NRC DOCKETS 50-321, 50-366
OPERATING LICENSES DPR-57, NPF-5
EDWIN I. HATCH NUCLEAR PLANT UNITS 1, 2
NRC I&E BULLETIN 80-11

NRC I&E BULLETIN 80-11, "MASONRY WALL DESIGN"

RESPONSE TO NRC REQUEST FOR
ADDITIONAL INFORMATION

EDWIN I. HATCH NUCLEAR PLANT

Project	HATCH-UNIT NO. 1 & 2	Prepared By	TINA C. SALSER	Date	12-9-80
Subject/Title	WALL MODIFICATION	Reviewed By	K. L. WILKINS	Date	12-10-80
C-130-1A & 1B (PSOC-EO-009)		Calculation Number		Sheet	1 of 6

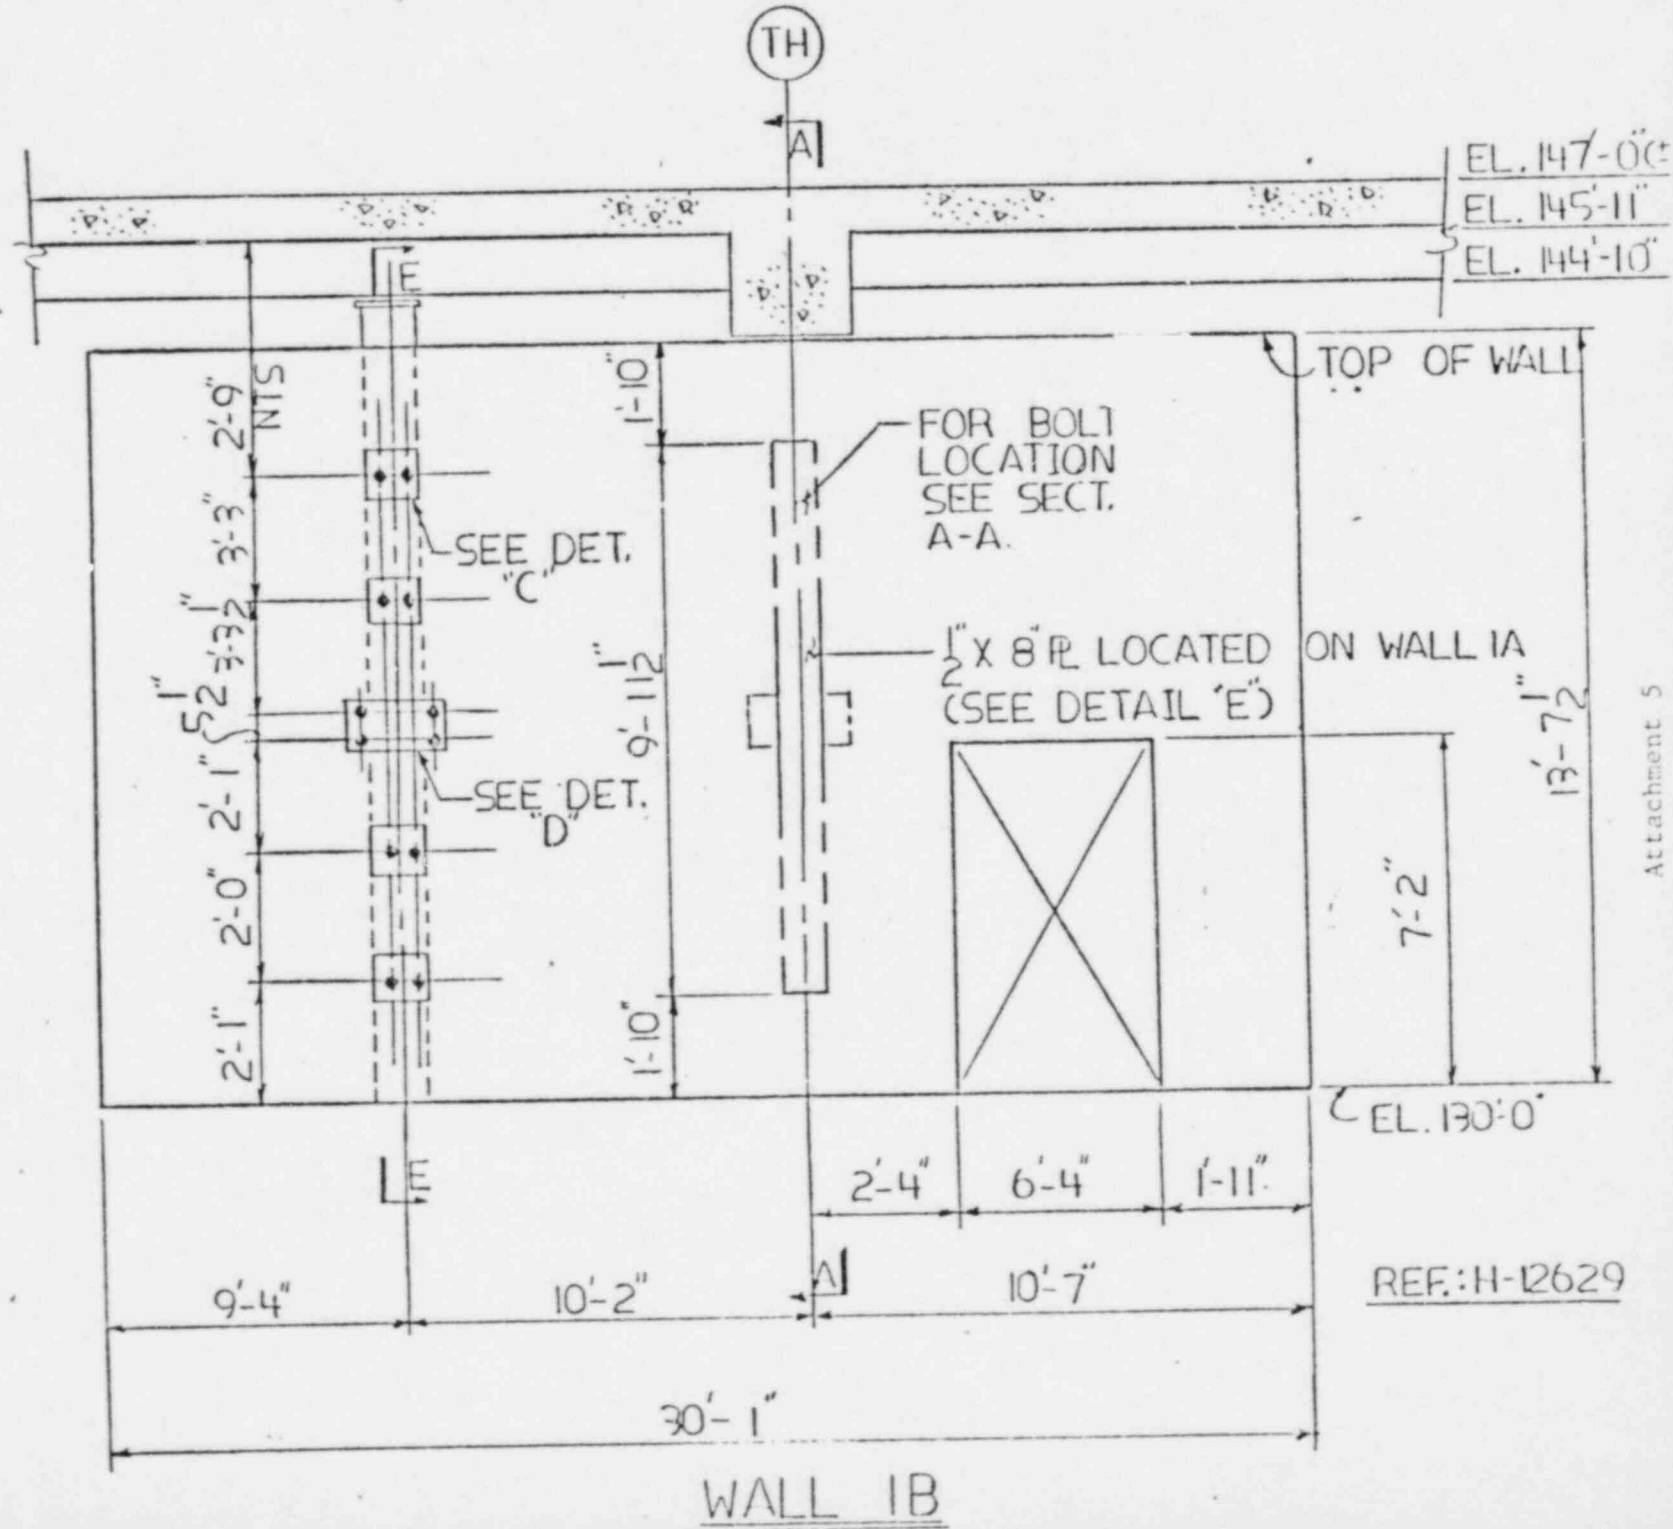
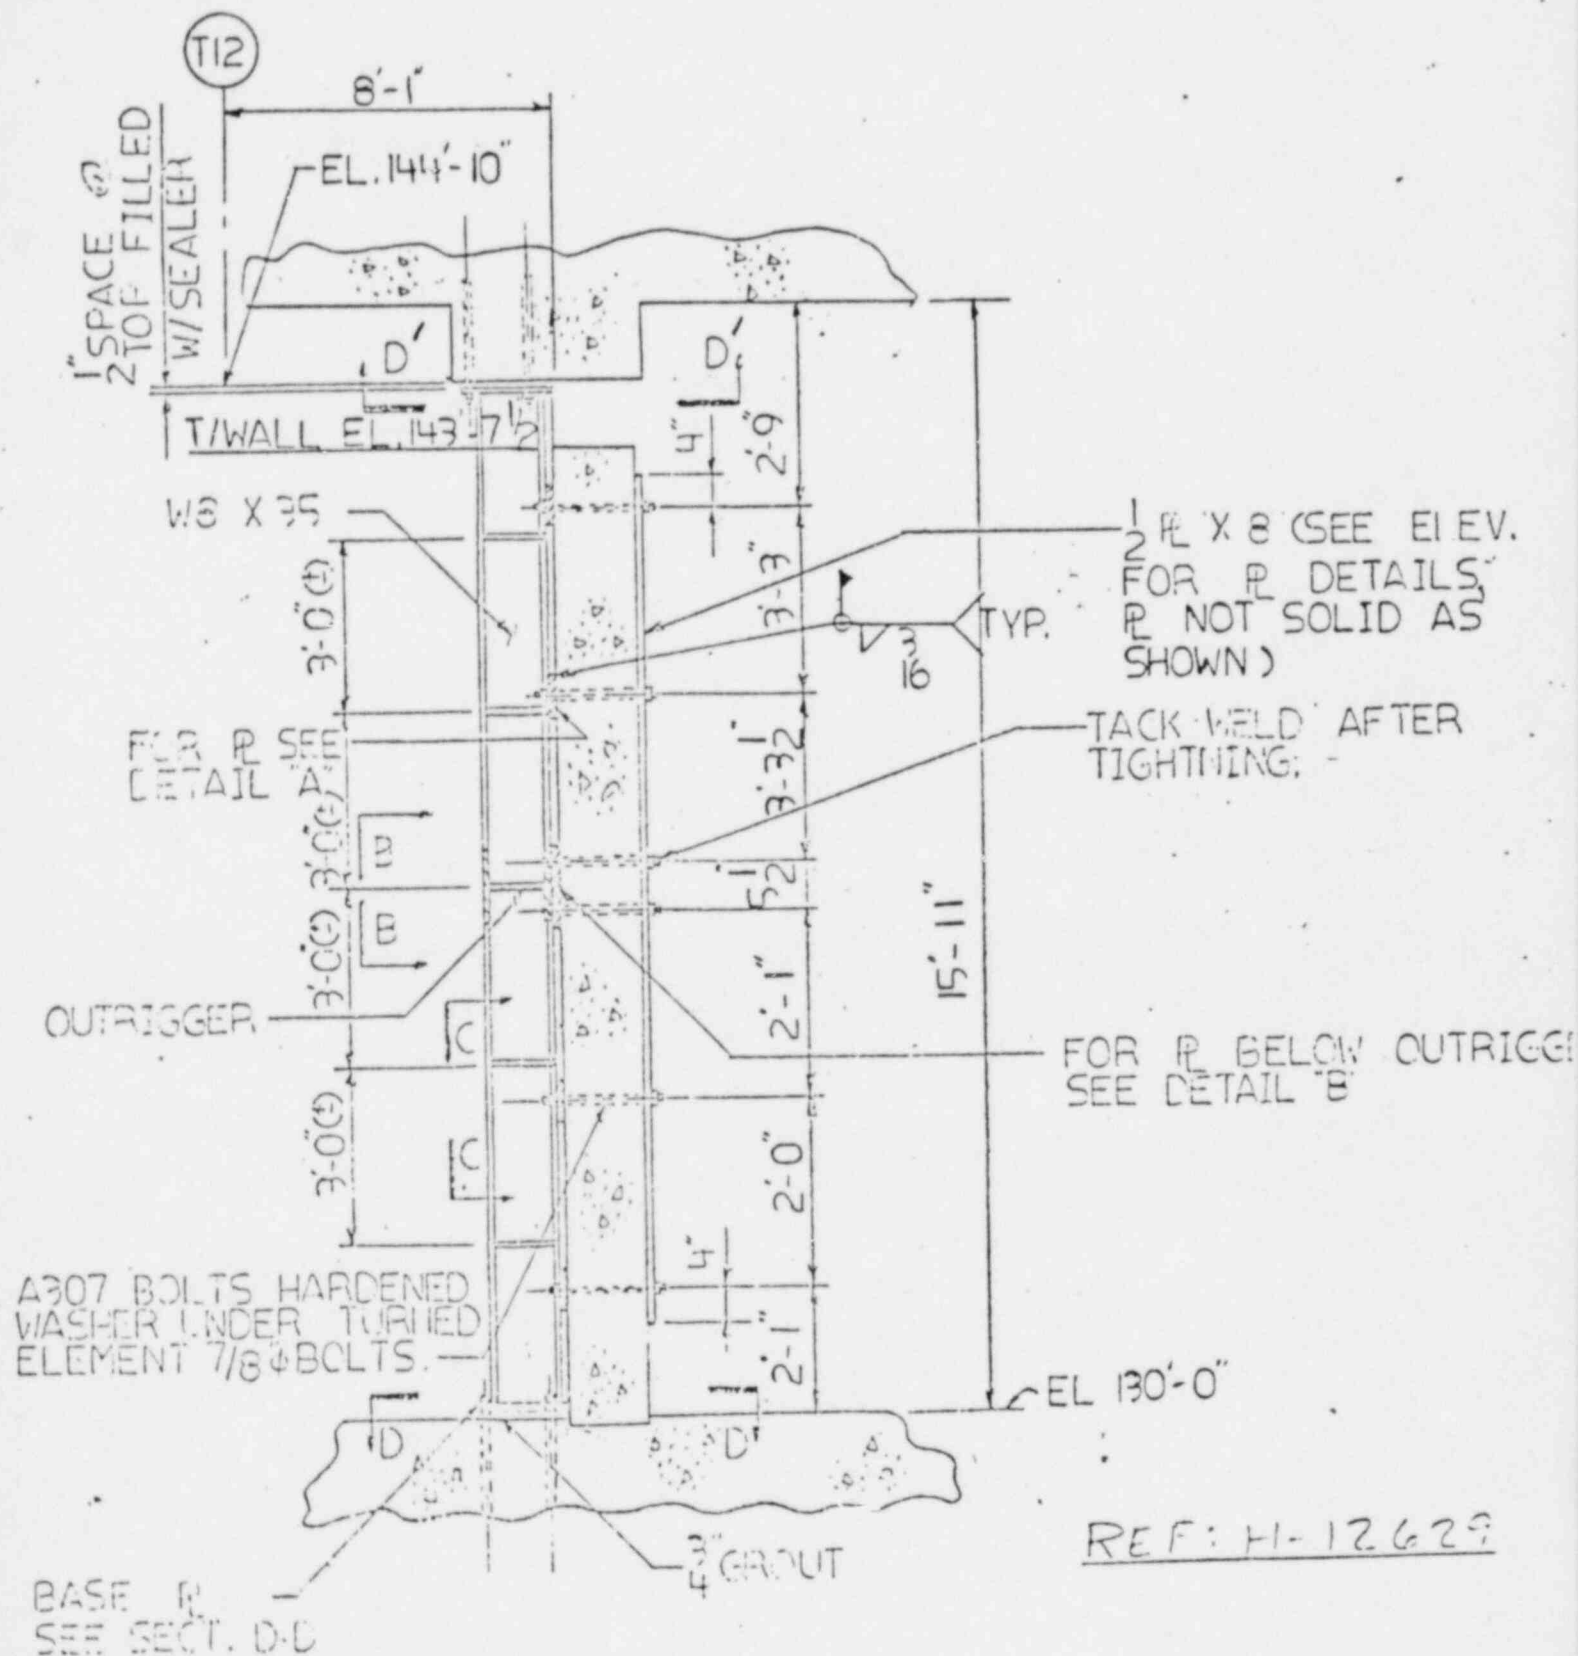
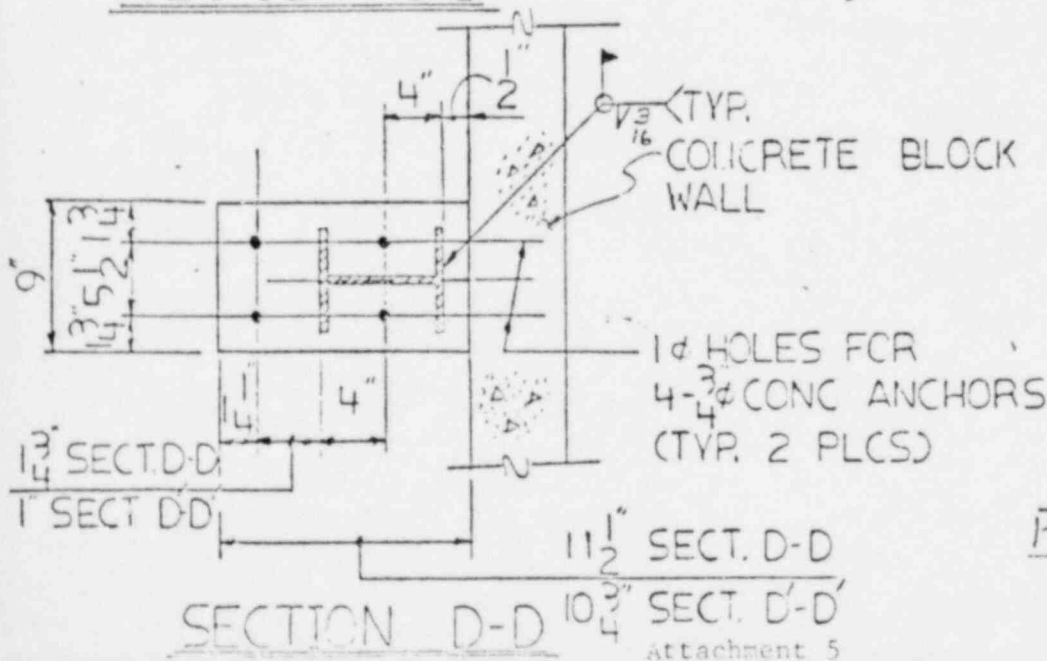
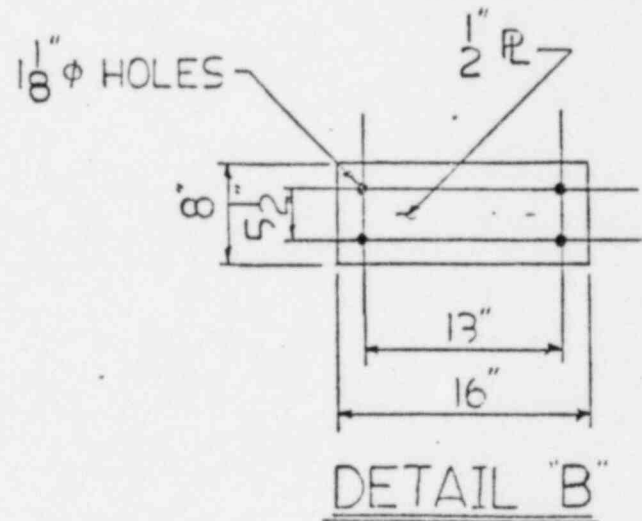
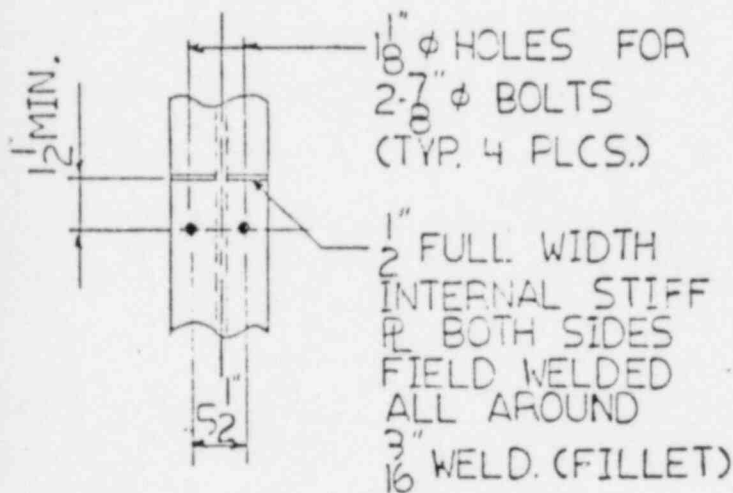
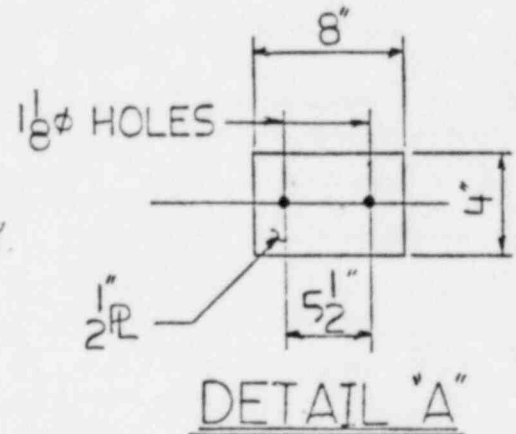
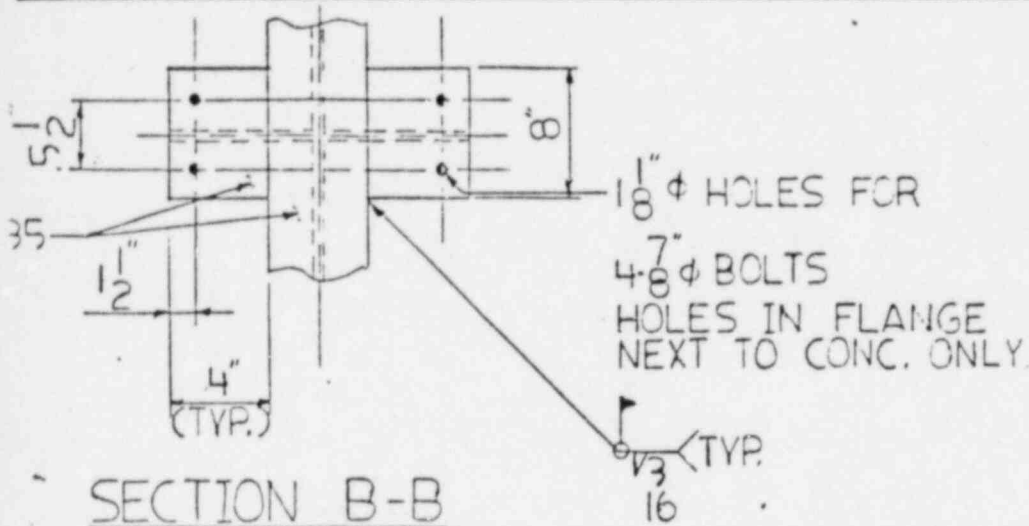
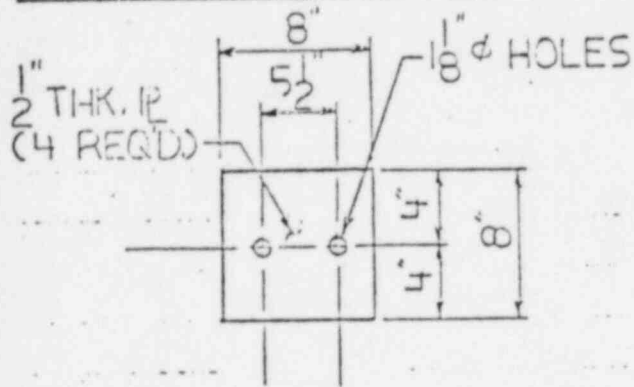
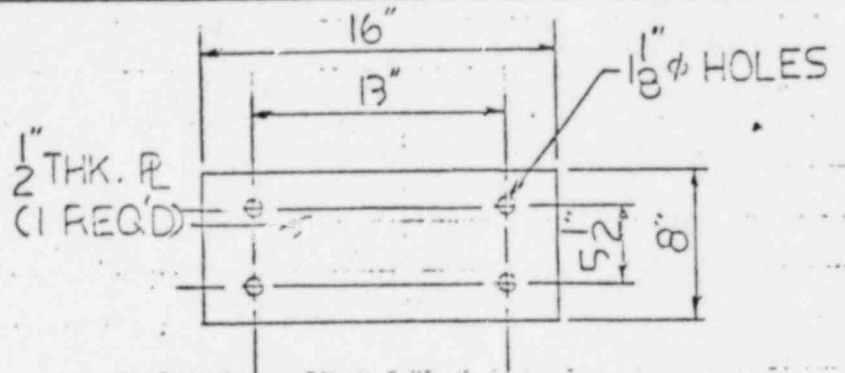
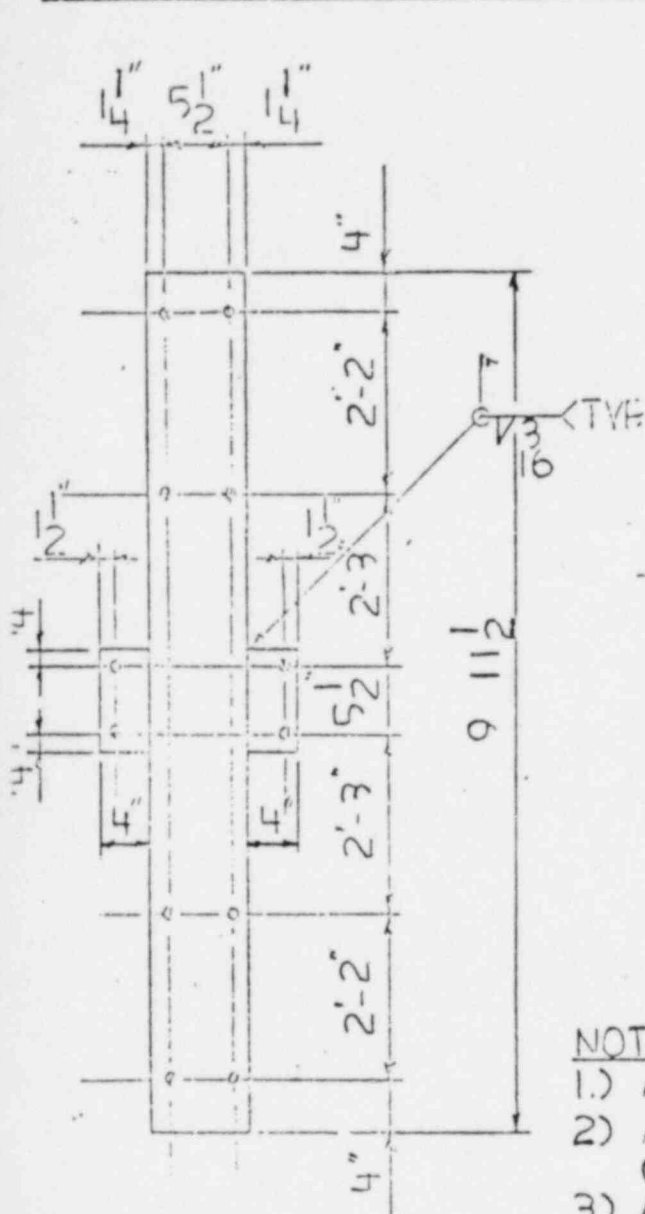
Provide details of modifications for all walls that do not satisfy the design allowables. Technical discussion should be provided detailing how these modifications will correct this deficiency. Also, provide the modification schedule.

A number of walls were modeled for STRUDL-DYNAL and had a finite element analysis run of the as-built condition, taking into account all loads and load combinations. A total of ten (10) walls were identified where calculated stresses exceeded allowable stresses. The results of the analysis showed that the effective horizontal span length of the wall should be reduced. Therefore, a point somewhere within the middle one-third of the span of the wall was chosen considering obstructions and installation problems, and one or more structural steel columns were erected to provide additional support for the wall. The column(s) were designed to withstand the applied loads and were used to brace the wall as shown in the attached sketches. The wall was then re-modeled for STRUDL-DYNAL, including the steel column, and a finite element analysis was performed again for all postulated loads and load combinations. Resulting moments and shears for the masonry wall and support column were checked against allowables. In addition, bolts, plates, and welds for the support having an angle brace were checked for worst-case loads. Wall number C130-14A&B had an angle brace attached to the ceiling on each side of the wall to provide lateral shear support and reduce a local overstress condition to within allowables. Following the analysis using the modified models, each wall was determined to satisfy all stress allowables.

Detailed sketches of the modification for each wall are shown in attachments 1 through 8. The field modifications for each wall are complete except for wall C164-4A&B and wall C130-39A&B. Both of these walls will be removed in the near future to allow for relocation of the shift supervisors office and modifications in the health physics area. Therefore, no modifications have been scheduled for these walls.
